CITY OF LA VISTA
PLANNING DIVISION

RECOMMENDATION REPORT

CASE NUMBERS: PPUD22-0003;

RE: Planned Unit Development Amendment – Initial Review Letter
Lot 2 Southport East Replat Two

c1.0

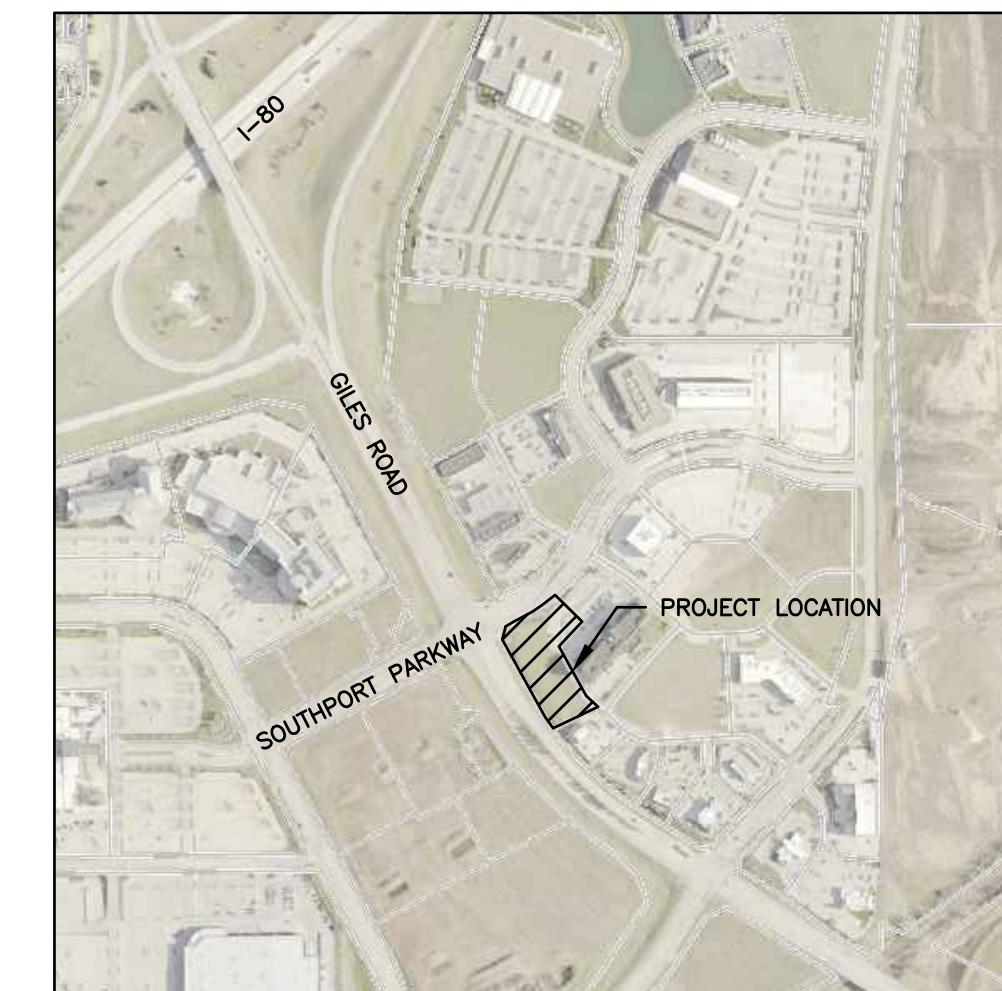
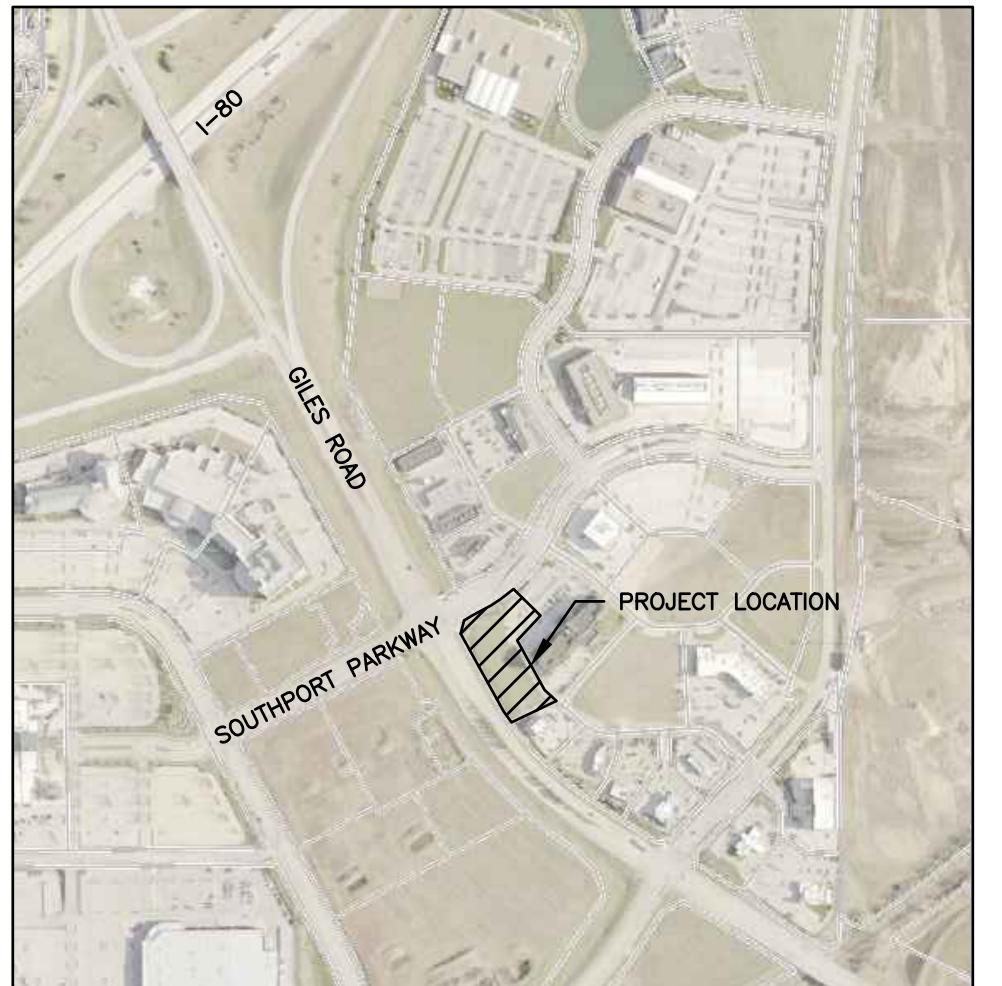
Sheet C1.0

15. Please submit all applicable easements and covenants with neighboring property owners, per Section 5.15.04.03.

16. Please include the heights of all proposed buildings on the project site, per Section 5.15.05.02.2.

17. Please update the legend showing the thickness of all P.C.C. pavement and sidewalks.
18. Please include calculations showing how stall count was determined and if parking stalls will be shared by proposed businesses, per Section 5.15.04.08.

Sheet C1.0

9. The PUD site plan identifies locations for two ground monument signs. Please include the setback dimensions for such signs in the site plan. The required setback for a ground monument sign (advertising a single tenant) is 10 feet. The northwestern-most sign is proposed to advertise both the First Watch restaurant and the general retail tenants, which would make this either a center ID sign or a project directory sign (see Section 7.01 of the La Vista Zoning Ordinance), which each require a 20-foot setback along arterial roads such as Giles Road. If you would like this sign to advertise more than one tenant, then it must be able to meet the 20-foot setback.

C2.0

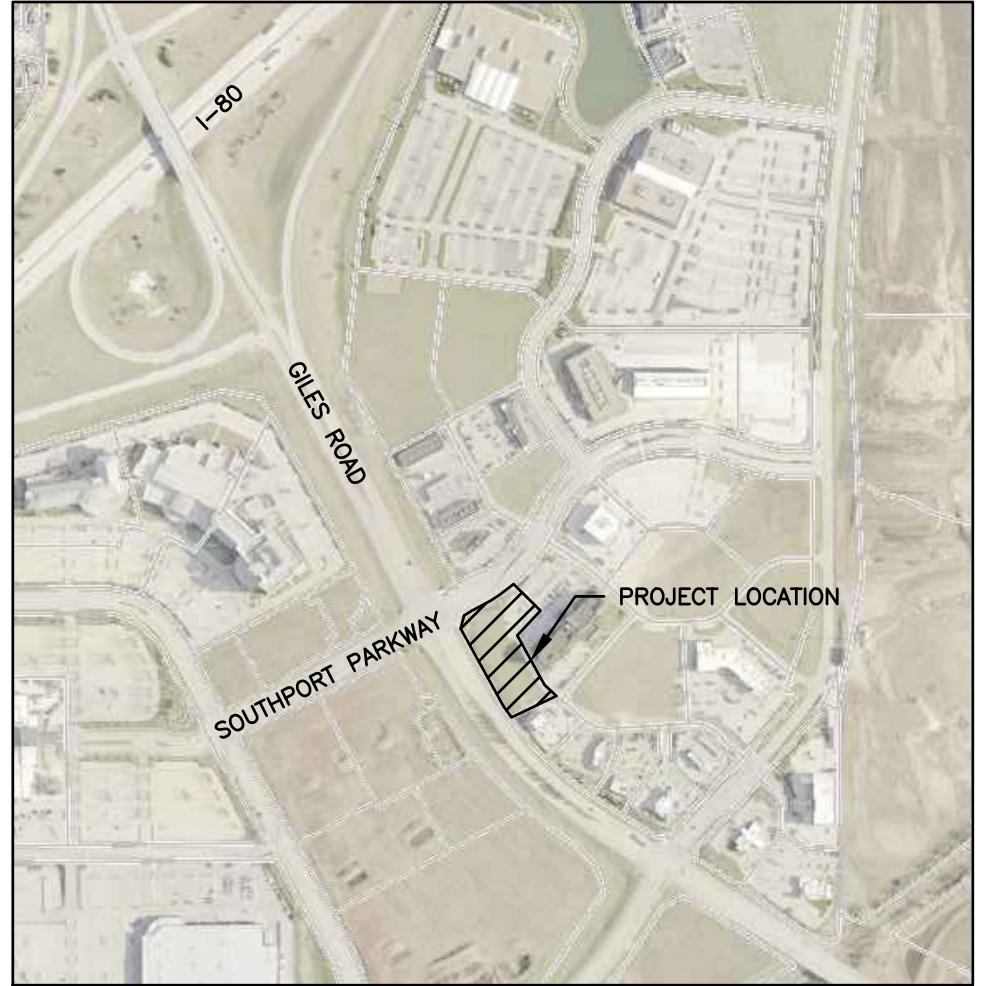
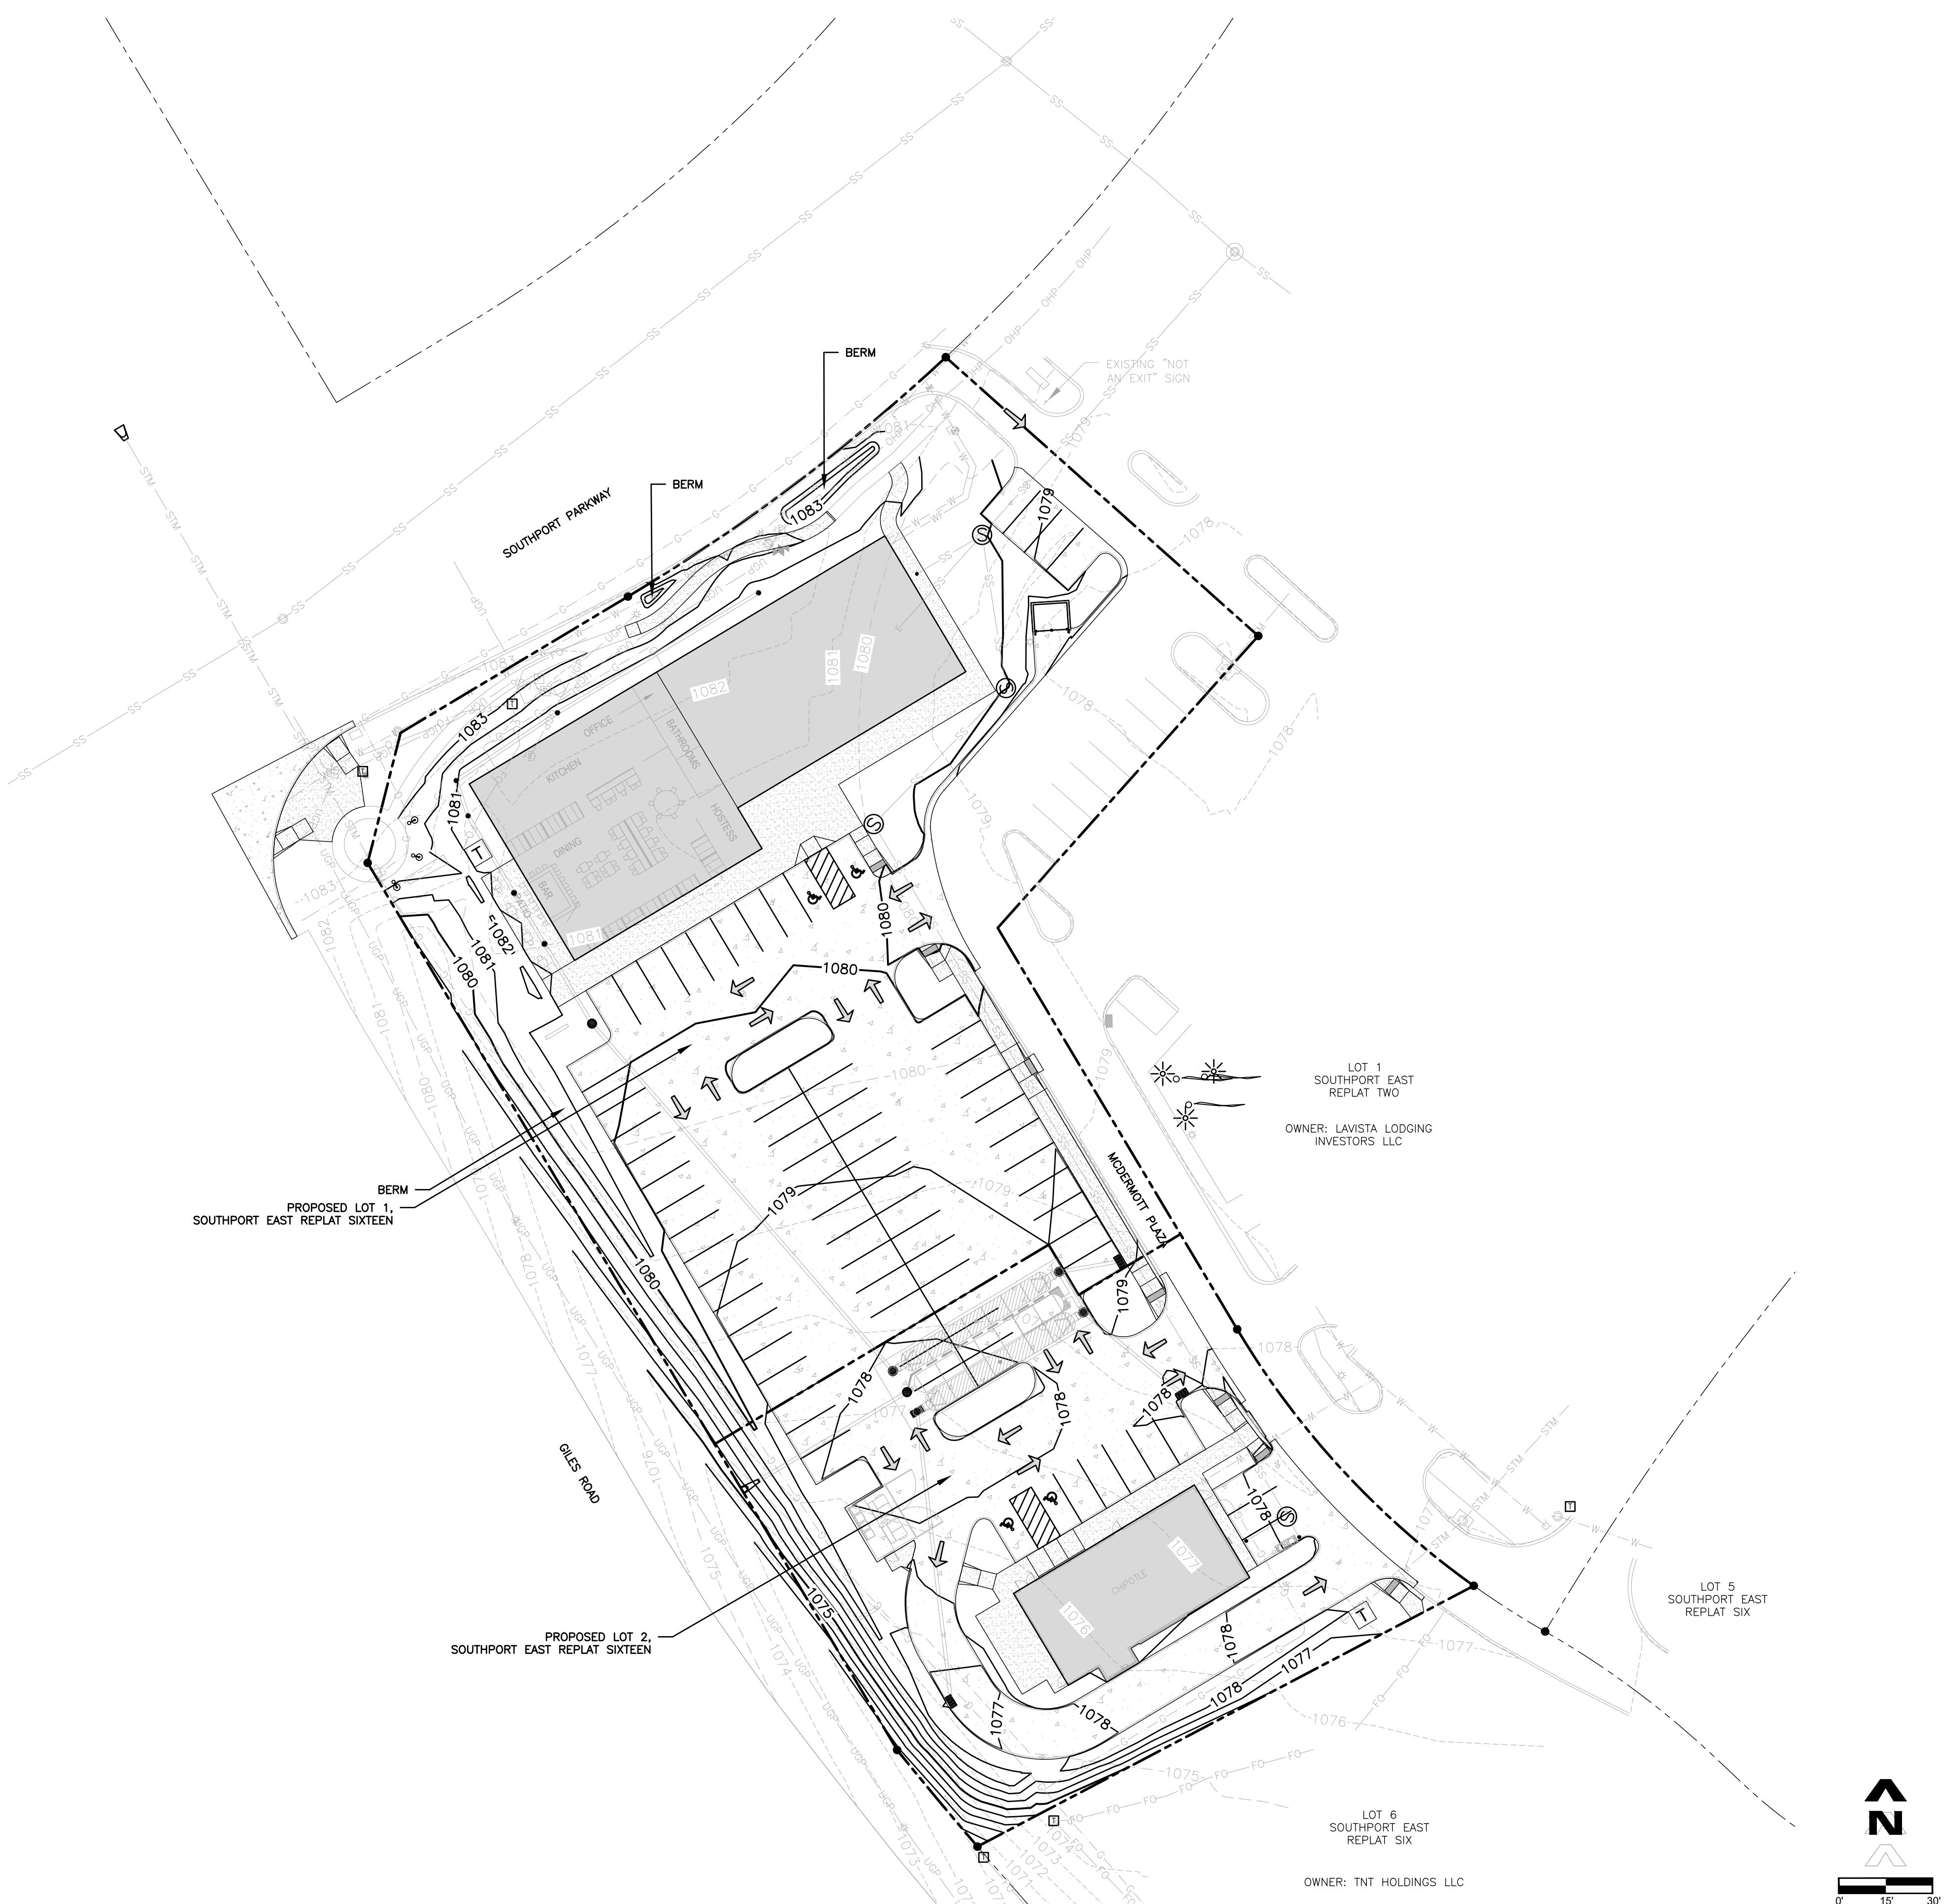
Sheet C2.0

19. Please confirm that grading will not interfere with the drainage swale on the neighboring lot located south of the construction activity.

C3.0

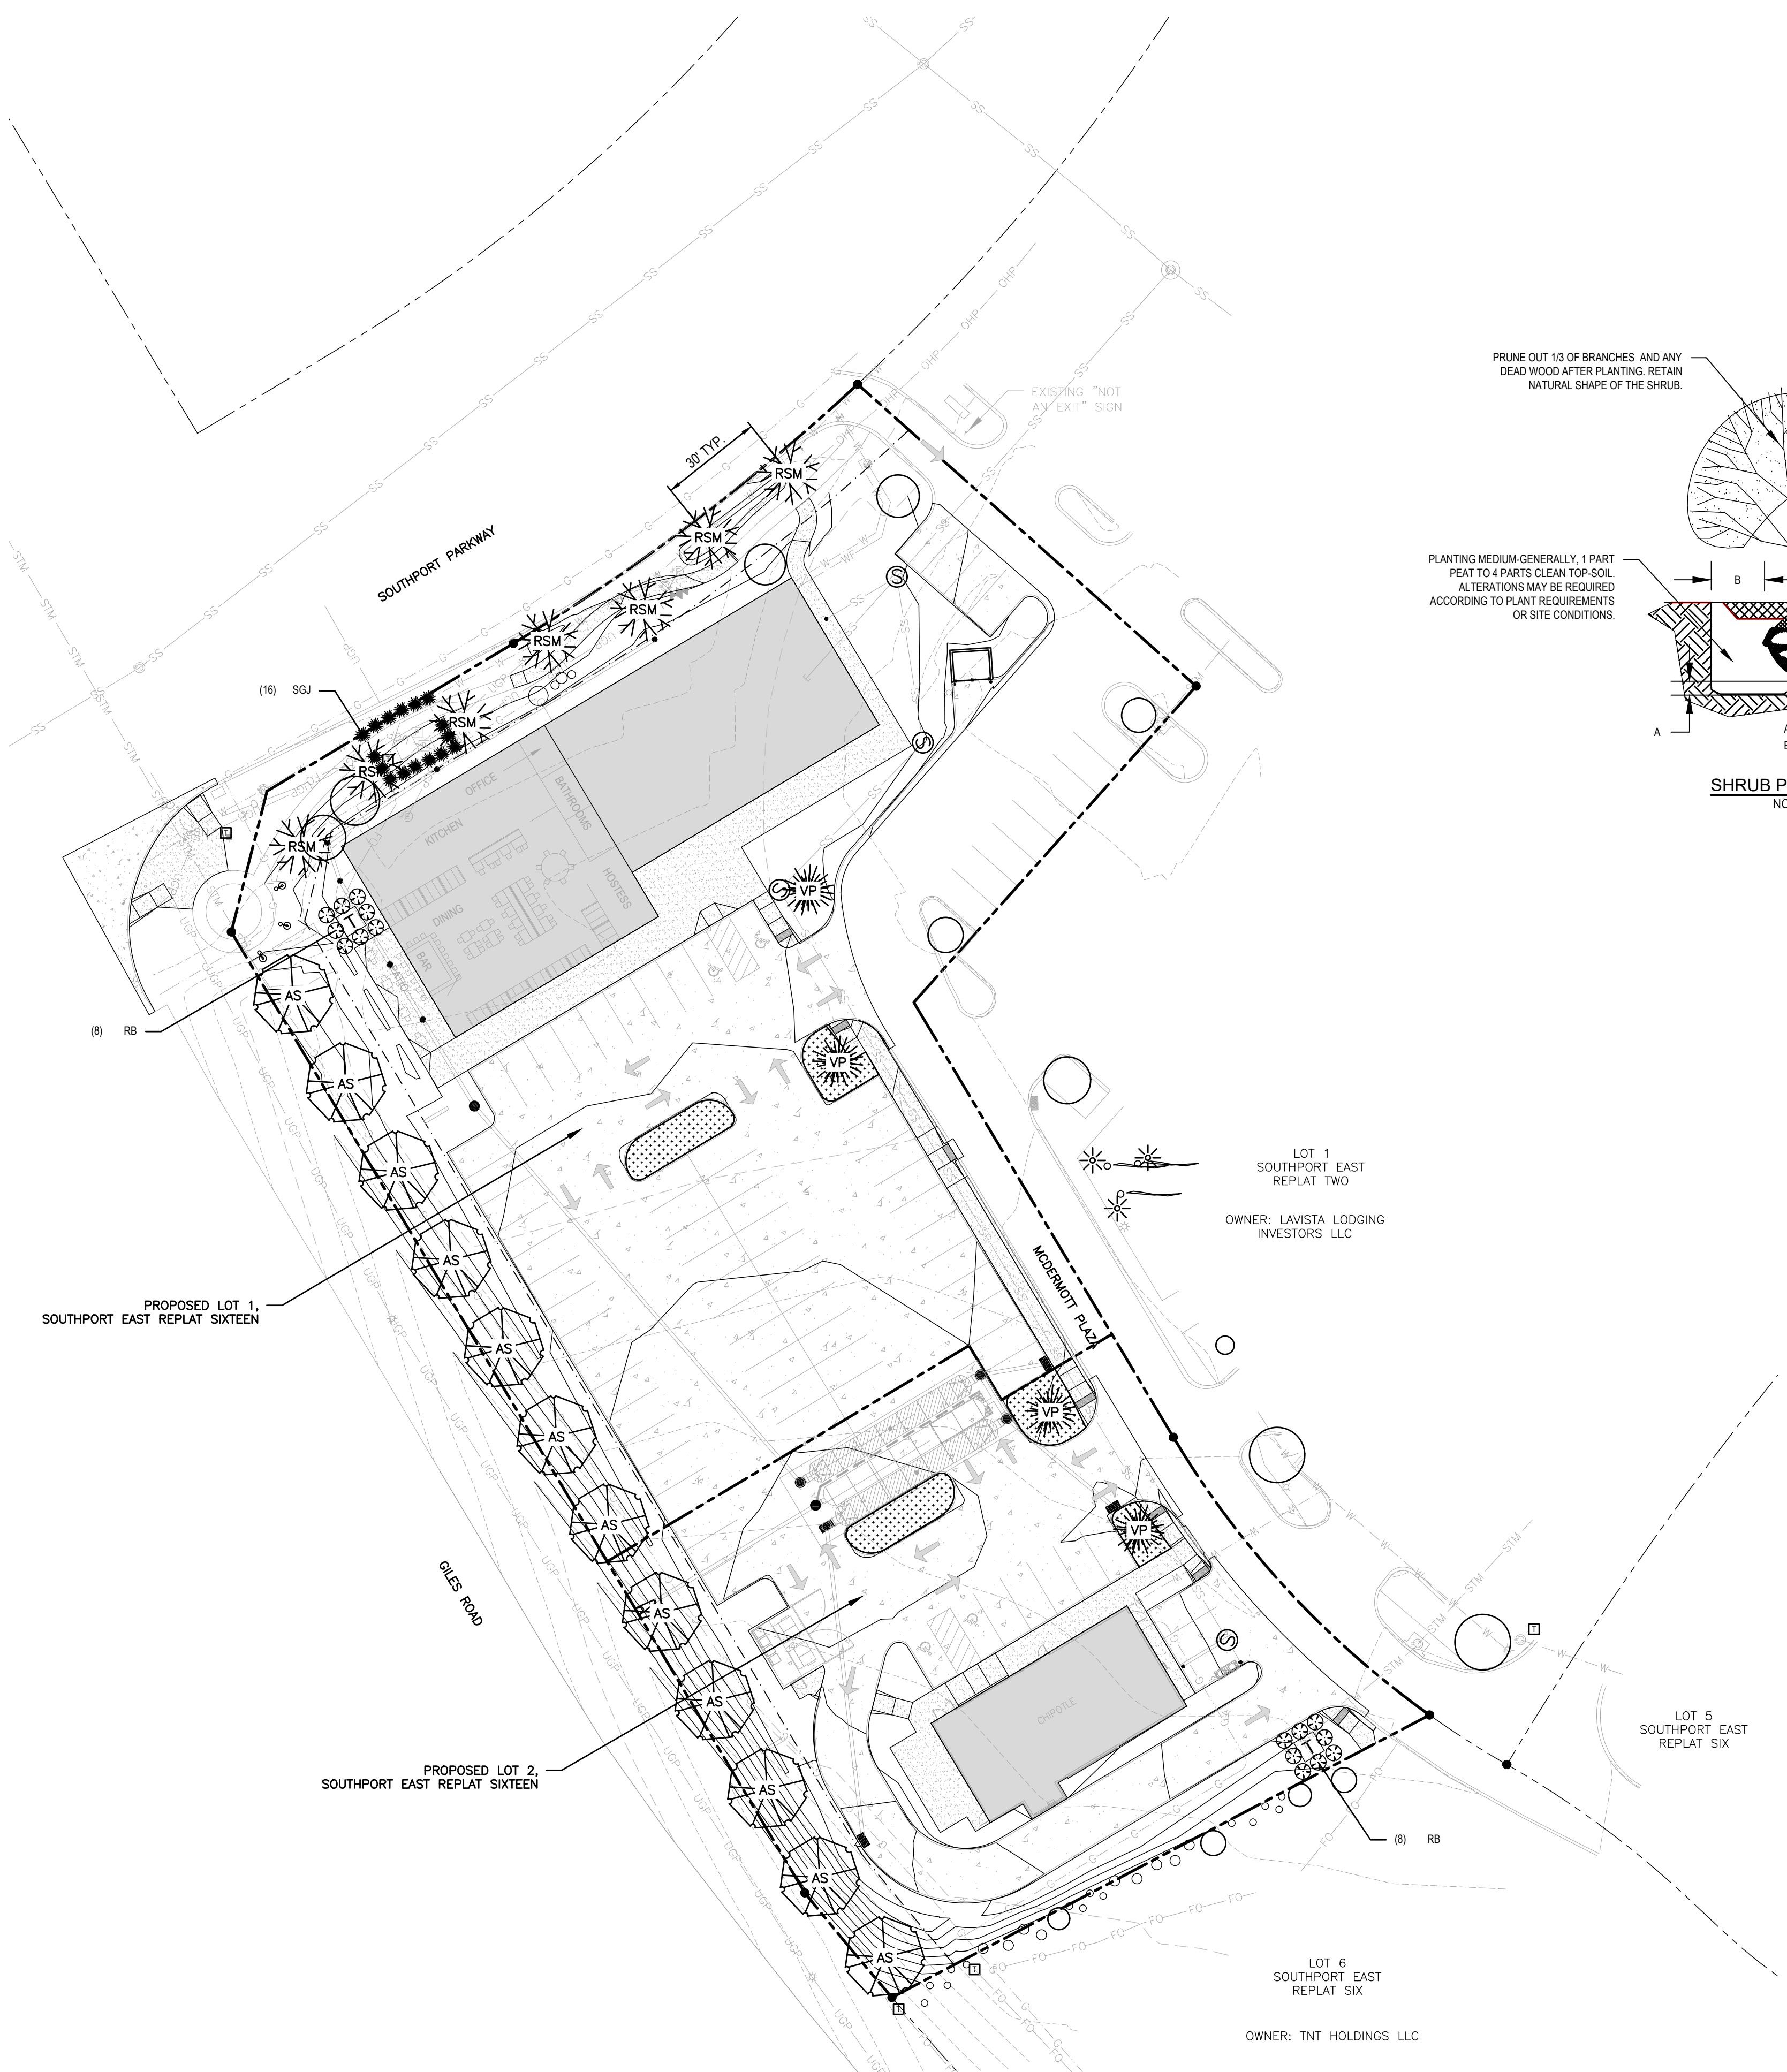
Sheet C3.0

20. The proposed number and location of storm inlets appear to be inadequate. Please provide further details on how the parking lot will drain, per Section 5.15.05.04.
21. Please show the point of connection and other pertinent design information for the sanitary sewer, per Section 5.15.05.04.
22. Please show the point of connection and other pertinent design information for the to the public stormwater infrastructure, per Section 5.15.05.04.
23. Please show locations of natural features such as ponds, tree clusters, and drainageways, per Section 5.15.05.02.10.
24. Please submit a post-construction stormwater management plan, inclusive of a drainage study. In addition, a NPDES grading permit will be required at time of building permit.

Sheet C3.0

10. Regarding Section 5.15.05.04, please be aware that manholes will be required at each change of alignment in the proposed sanitary sewer and that they must be accessible by maintenance vehicles at all times.
11. Please confirm the existence of the sanitary sewer where the proposed manhole connection is located.
12. Please provide for review a draft sanitary sewer easement in coordination with the property owner of Lot 1 Southport East Replat 2. A sanitary sewer easement will be required between Lots 1 and 2 for the conveyance of sanitary waste from Lot 2.
